Access Compliance Report Public Rights-of-Way (Curb Ramps)

Main Street: BALLANTYNE_CORPORATE_PCross Street: N/A Intersection ID: 10020374 Location: S

ADA ID: B06FFA94836A Ramp Type: Perp Initial Pass/Fail: Fail **Overall Compliance: No Severity Score:** 35

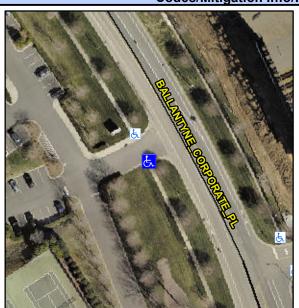
ENTRANCE Street 1 Name Stop Condition-Street 2 StopSign Street 2 Name N/A Stop Condition-Street 1 N/A Possible Solutions: Remove & Replace Entire Ramp. Surveyor Notes: N/A PROW/ADA: Not Found, R304.5.1, R304.2.2, R304.5.3

Field Measurements/Component Compliance							
	Compliance Description		Data	Compliance De		Description	Data
	N/A	Ramp Length (in)	71.0	No	Ramp	Slope (%)	14.9
	No	Ramp Width (in)	47.0	No	Ramp	XSlope (%)	2.6
	N/A	Flare Type LT	N/A	N/A	Flare	Type RT	N/A
	N/A	Flare Slope LT (%)	N/A	N/A	Flare	Slope RT (%)	N/A
	N/A	Flare Traversable LT?	N/A	N/A	Flare	Traversable RT?	N/A
	N/A	Landing Length (in)	N/A	N/A	DWS	Provided?	N/A
	N/A	Landing Width (in)	N/A	N/A	DWS	Contrast?	N/A
	N/A	Landing Slope (%)	N/A	N/A	DWS	Length (in)	N/A
	N/A	Landing X Slope (%)	N/A	N/A	DWS	Full Width?	N/A
	N/A	Landing Curb? (Y/N)	N/A	N/A	DWS	Offset (in)	N/A
	N/A	Shared Landing?	N/A				
	N/A	Gutter Ponding?	N/A	N/A	Gutte	r Slope (%)	N/A
	N/A	Gutter Lip Ht (in)	N/A	N/A	Gutte	r X Slope (%)	N/A
	N/A	Painted X Walk1?	No	N/A	Painte	ed X Walk2?	N/A
		X Walk 1 Direction	To NW		X Wa	lk 2 Direction	N/A
	N/A	X Walk 1 Width (in)	N/A	N/A	X Wa	lk 2 Width (in)	N/A
